**GENOA CHARTER TOWNSHIP  
PLANNING COMMISSION  
PUBLIC HEARING  
APRIL 11, 2022  
6:30 P.M.  
AGENDA**

<b>Attention:</b>	Kelly Van Marter, AICP Planning Director and Assistant Township Manager
<b>Subject:</b>	Bible Baptist Church – Special Land Use and Site Plan Review #3
<b>Location:</b>	3850 Golf Club Road – southwest corner of Latson and Golf Club Roads
<b>Zoning:</b>	LDR Low Density Residential District

At the Township’s request, we have reviewed the revised submittal from Bible Baptist Church requesting special land use and site plan review/approval for a new church and activities within the natural feature setback (site plan dated 3/16/22).

**NATURAL FEATURES PLAN**

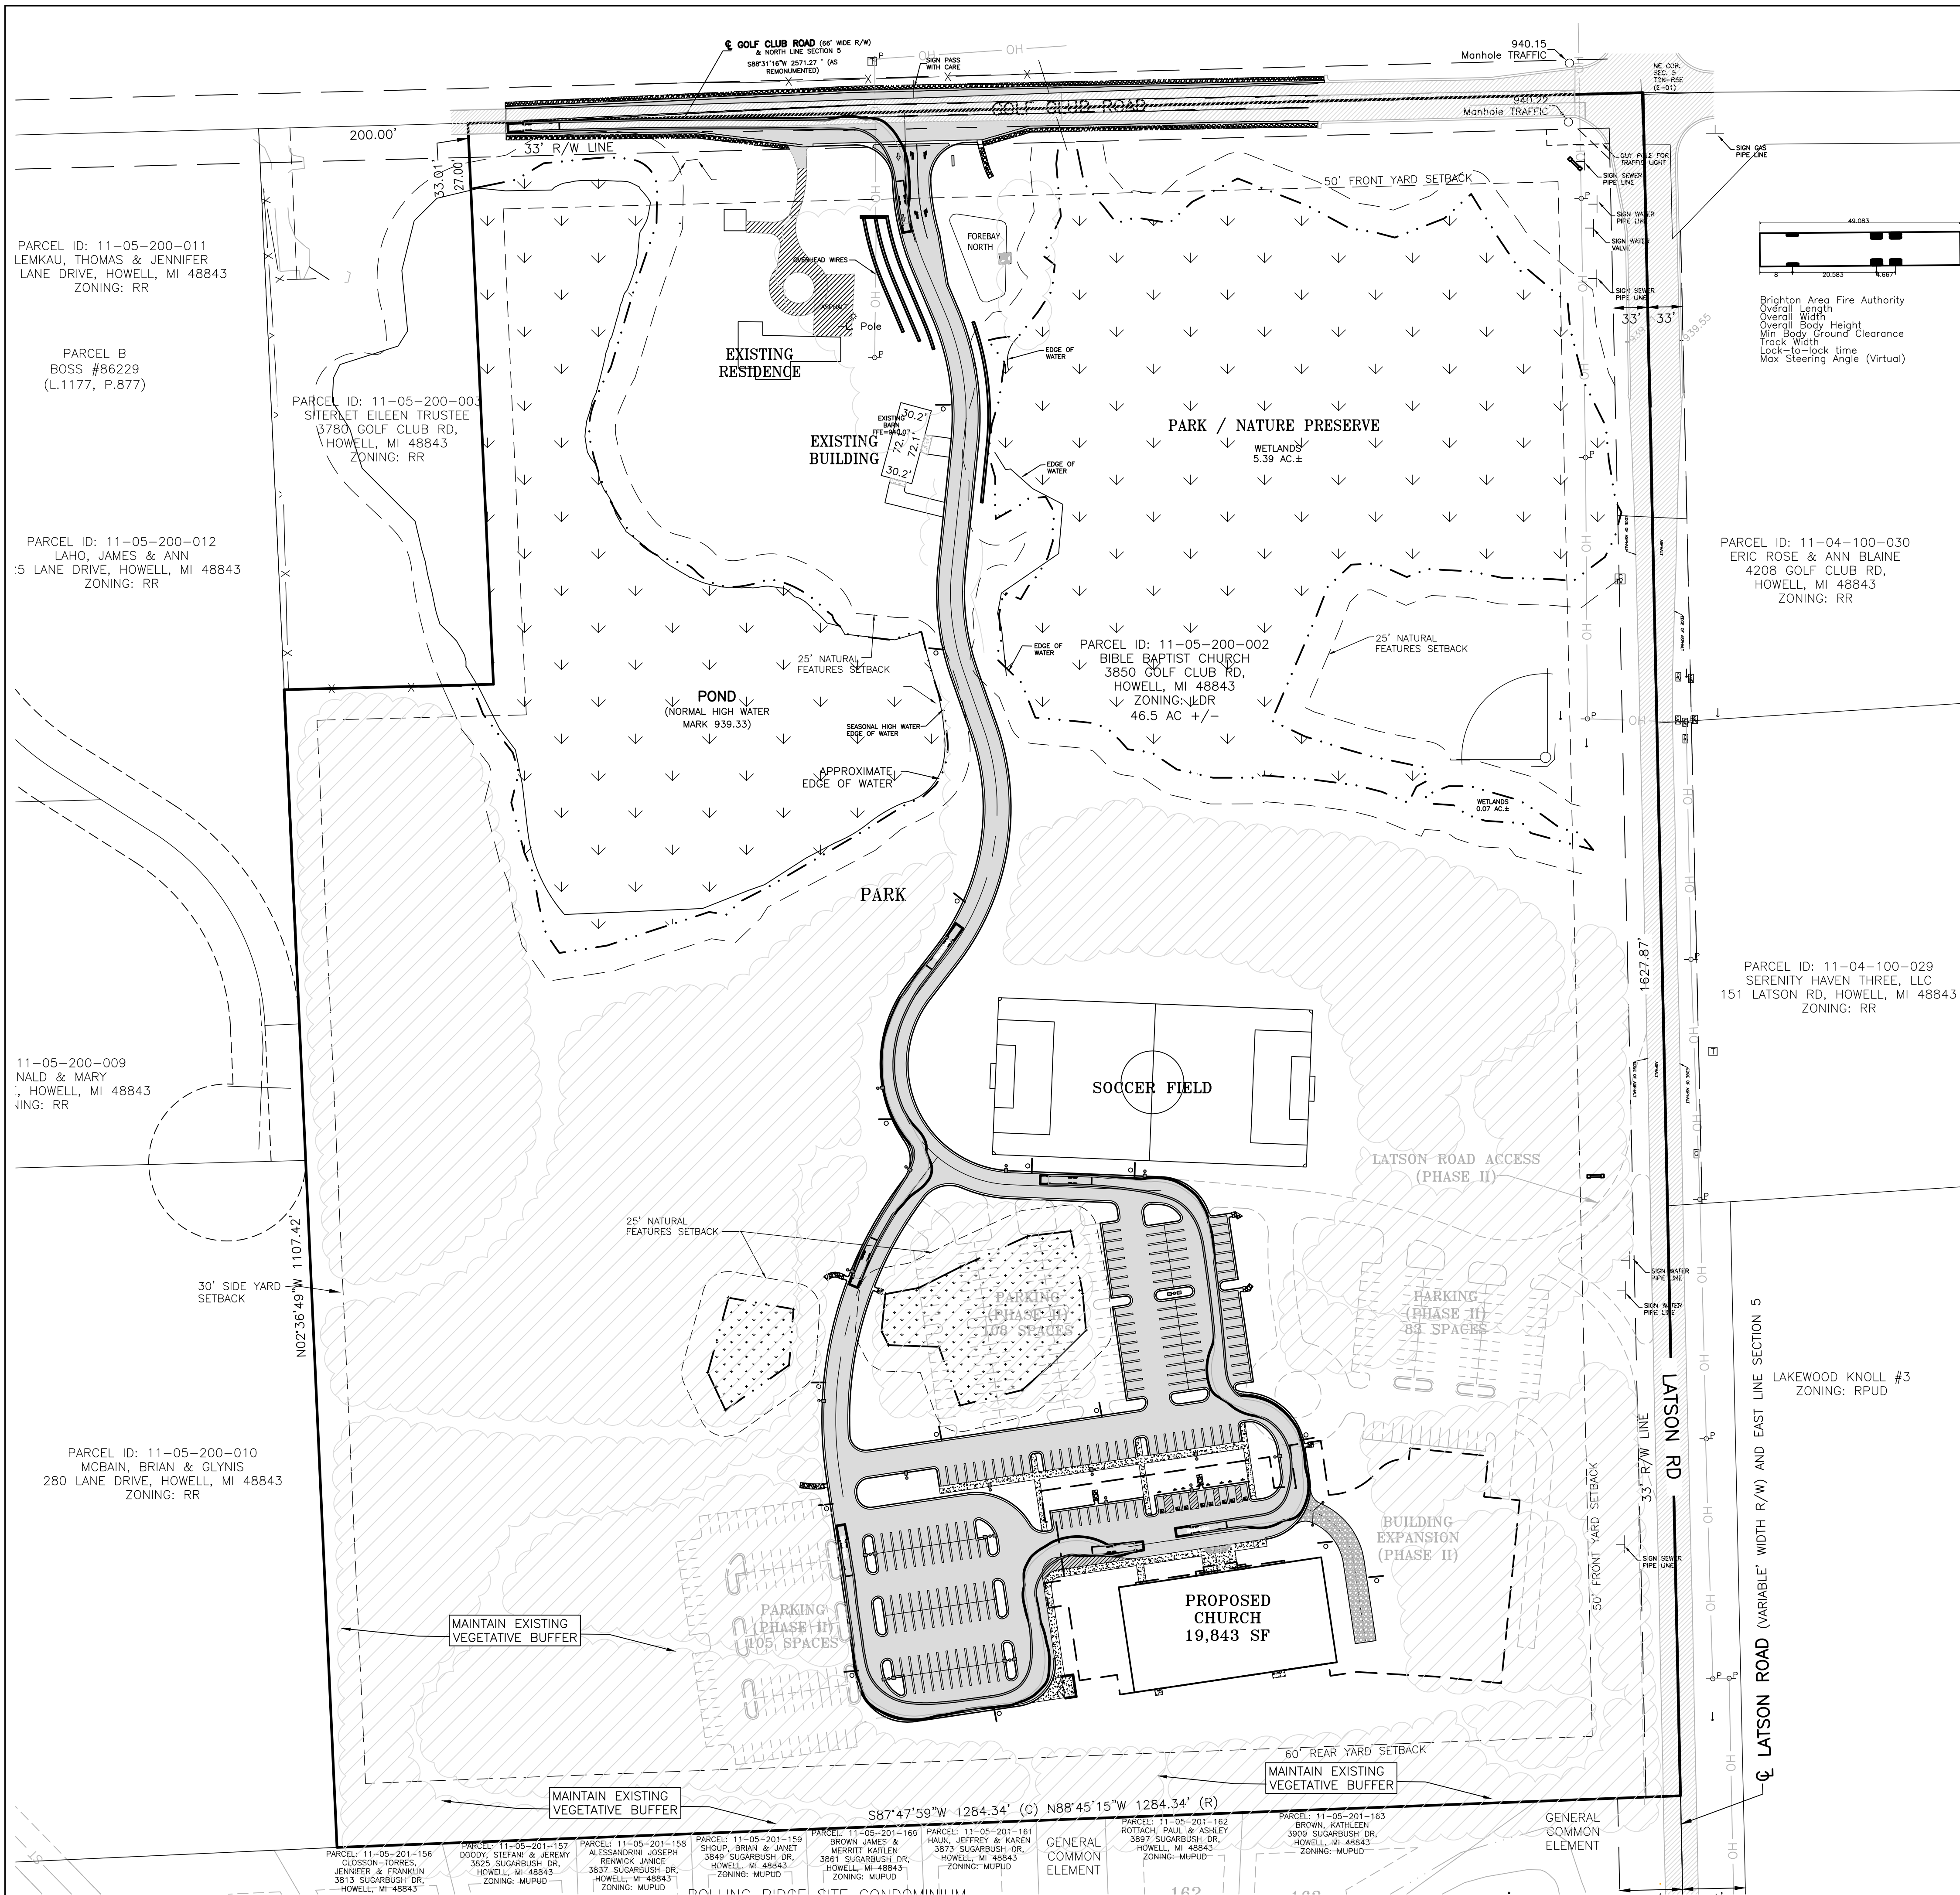
Based on the limits of disturbance (depicted on Sheet 3), the westerly 450 feet of the property will remain undisturbed.

SCALE: 1" = 80'  
 JOB NO. 21-542  
 DATE 2/1/2022  
 SHEET NO. 4

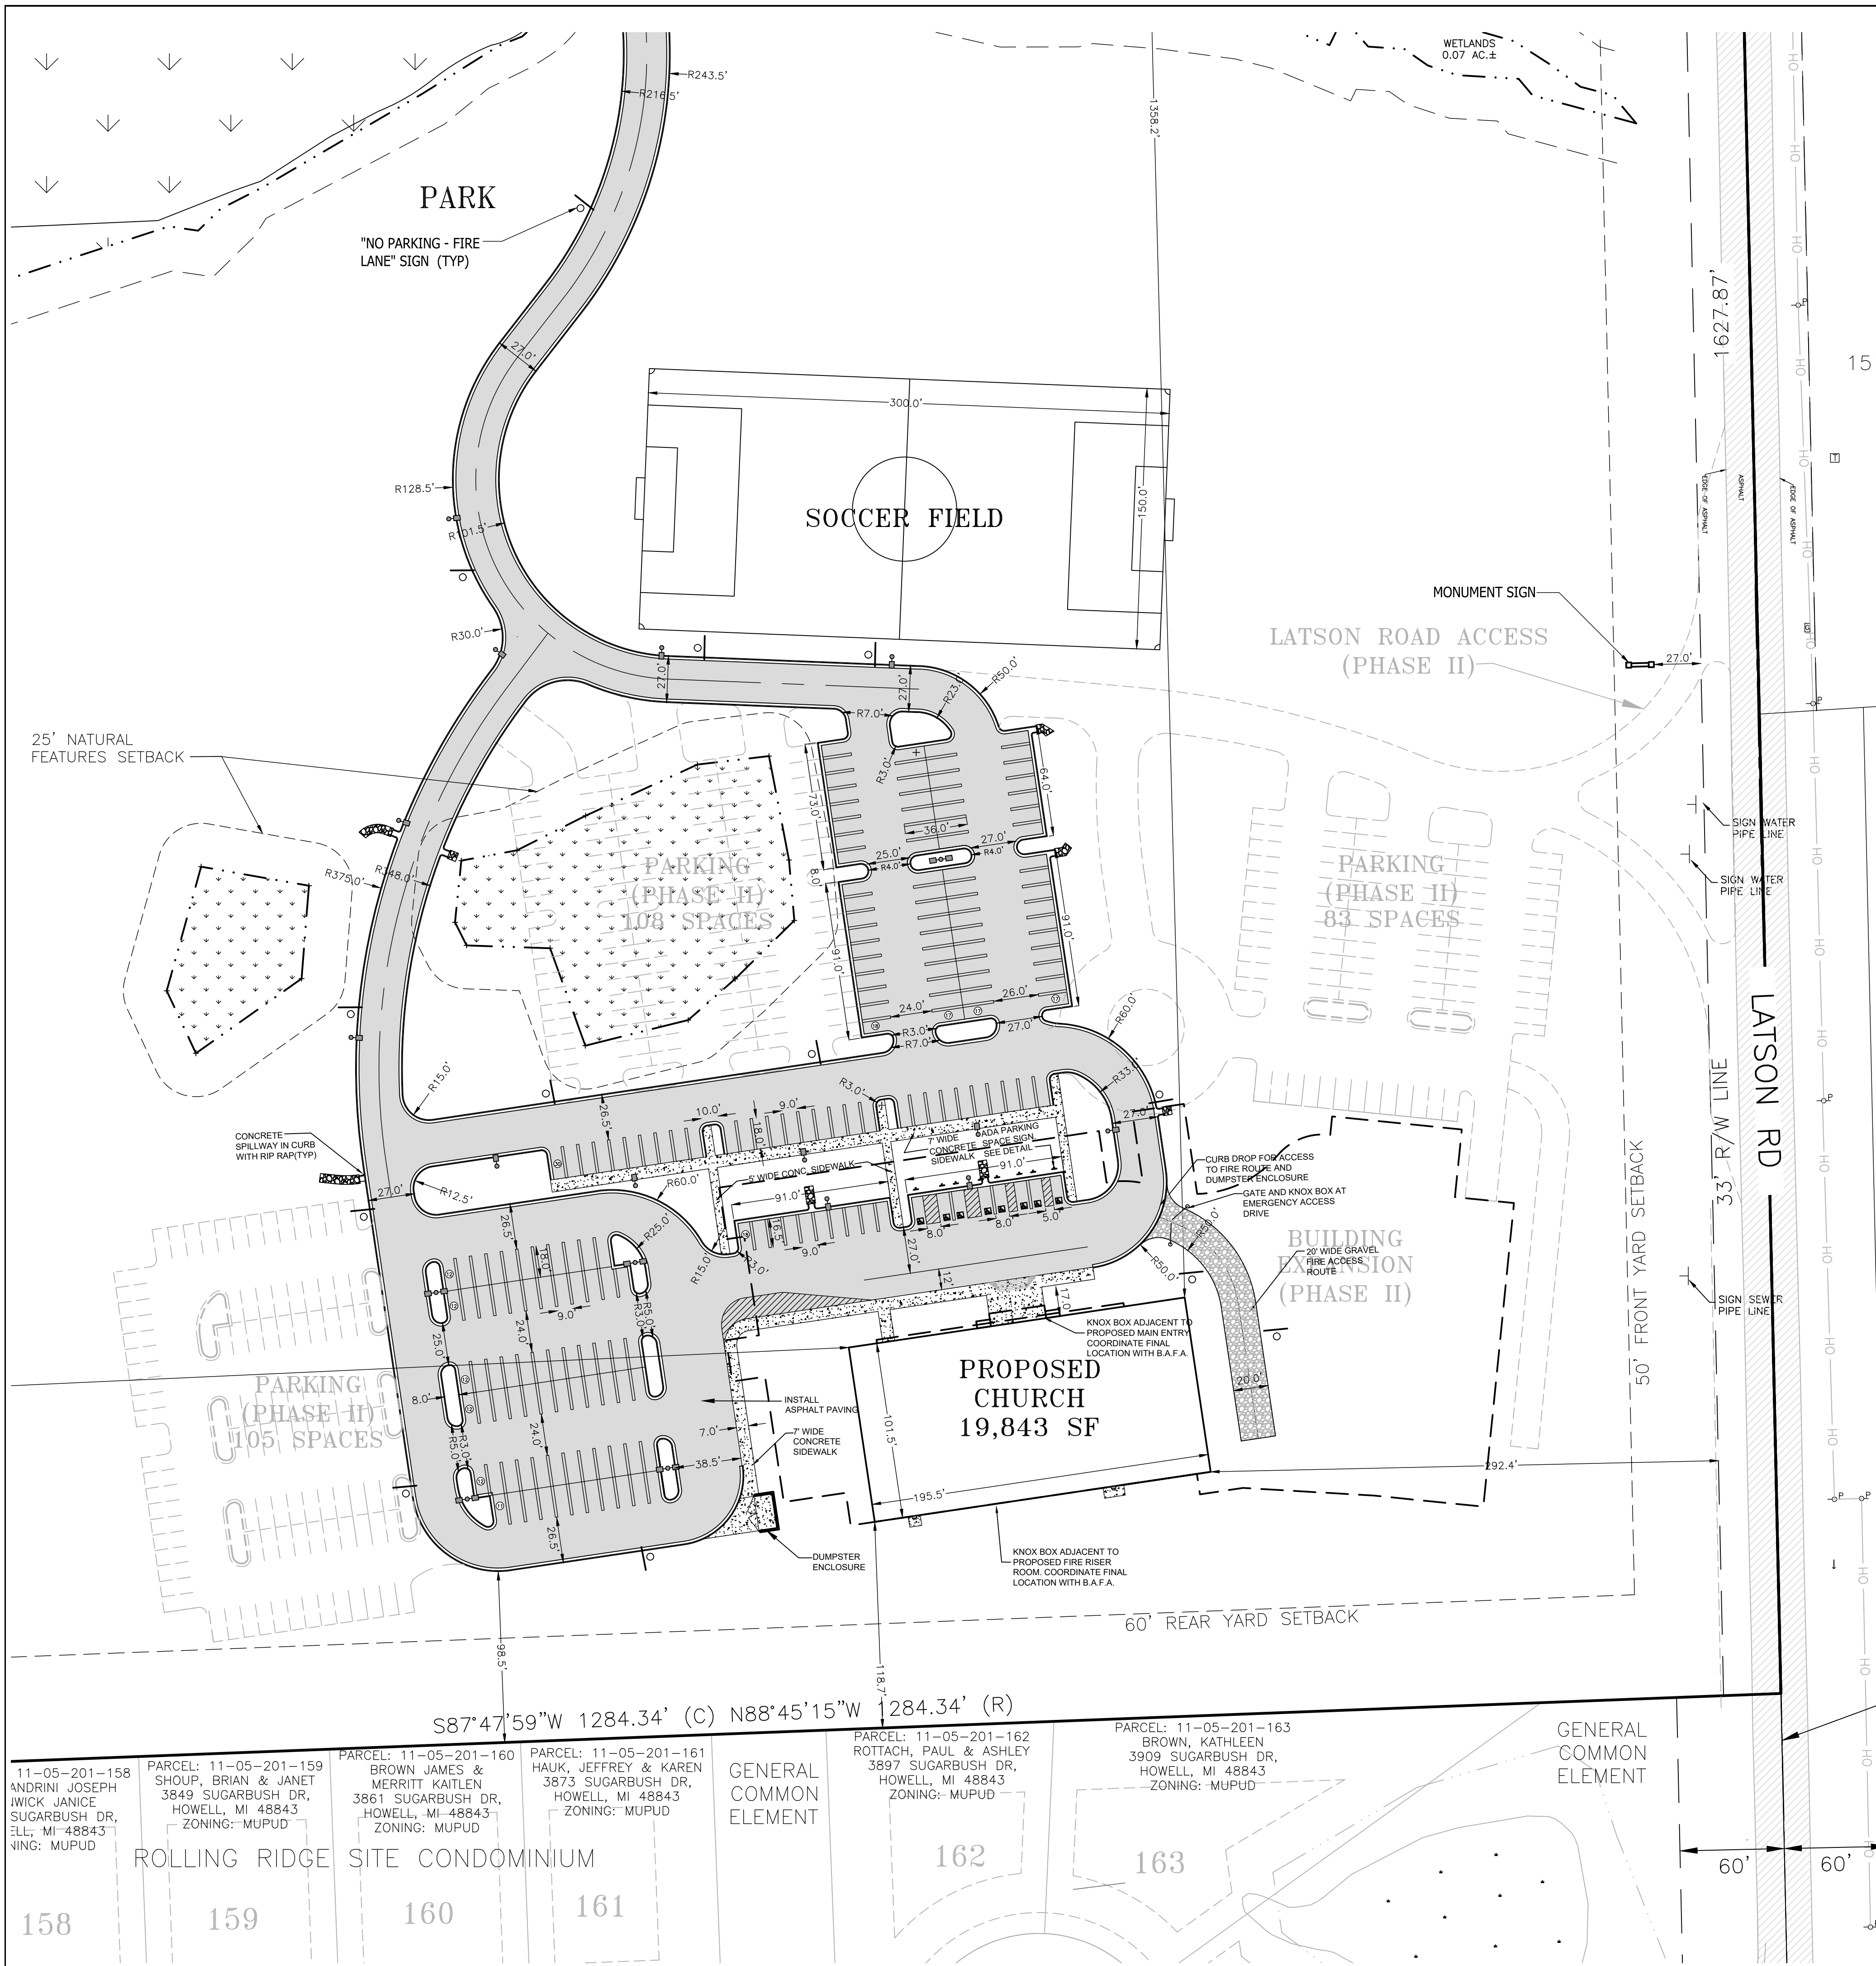
The notes on Sheet 4 identify a seating capacity of 506, which results in a minimum lot area requirement of 4 to 5 acres. The 46.5-acre site greatly exceeds the minimum lot area required by this criterion.

**NATURAL FEATURES SETBACK DISTURBANCE NARRATIVE:**

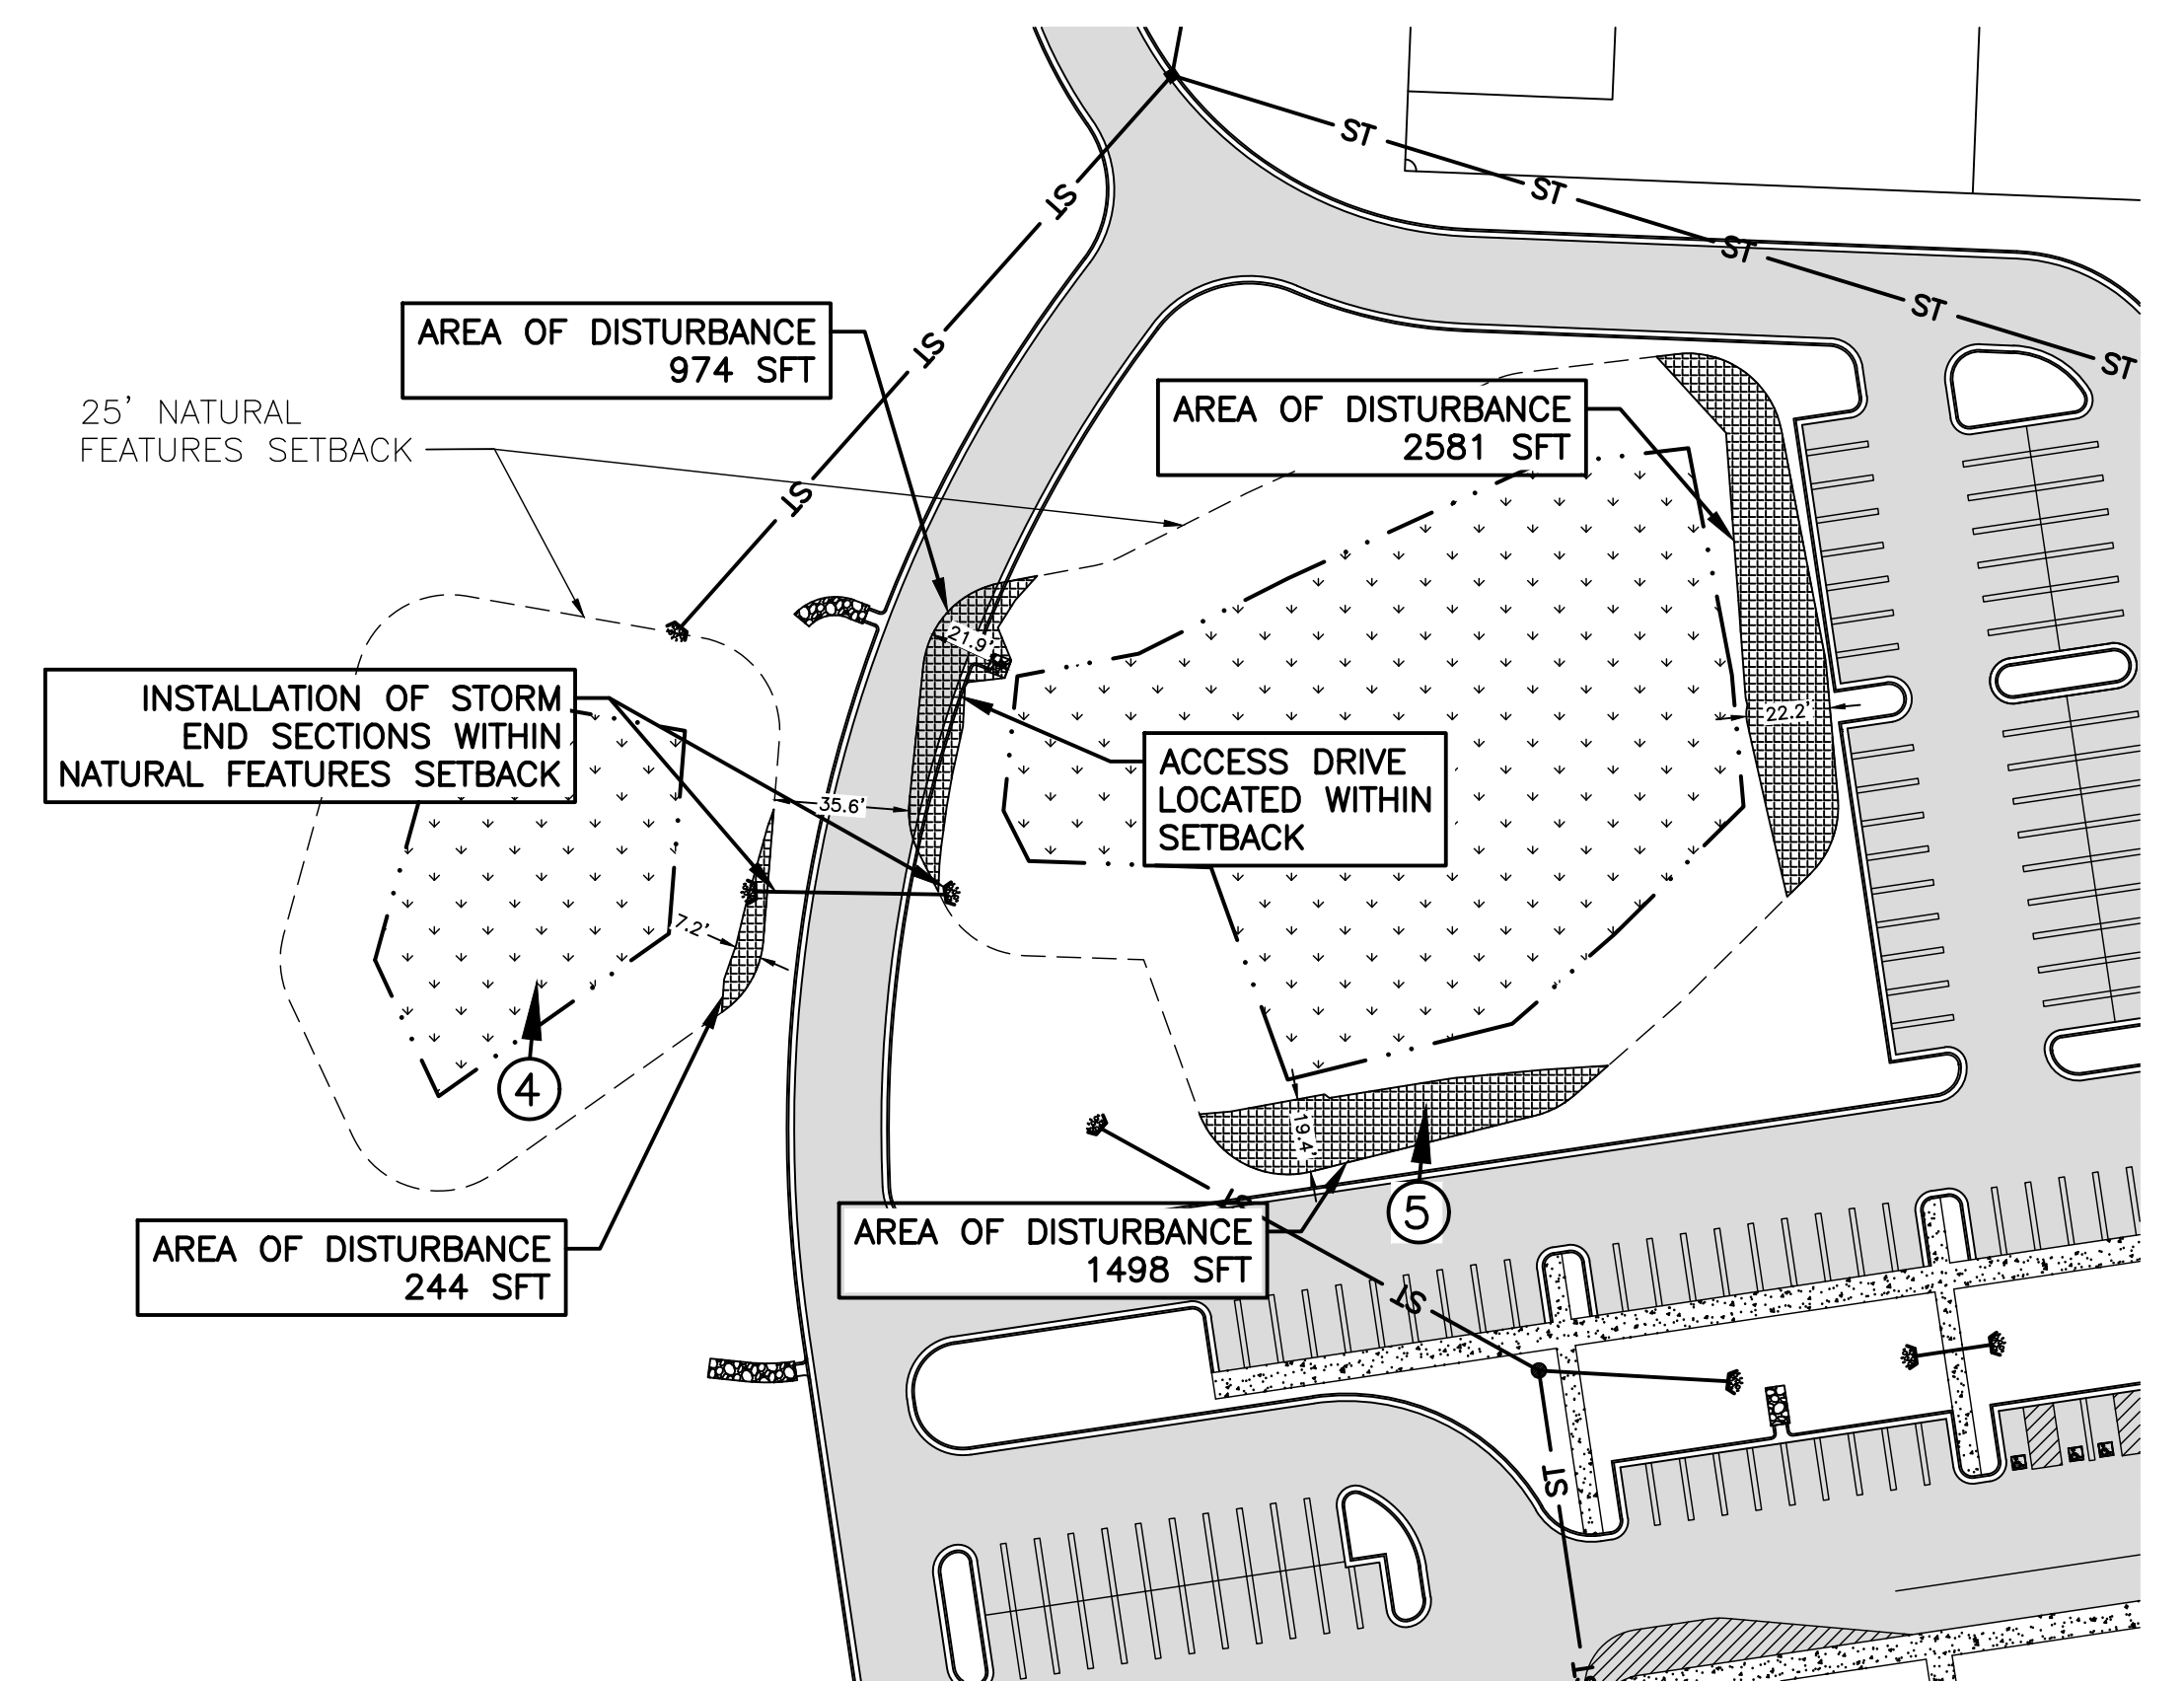
The revised submittal includes a detailed drawing of the proposed encroachments for both the northerly and southerly portions of the site (Sheet 13).

Given the location of the wetlands, site topography, and current conditions on Latson Road, encroachments are necessary to construct a driveway to/from Golf Club Road. Notes on Sheet 13 also indicate that the driveway has been designed to minimize disturbance of the natural feature setback area.
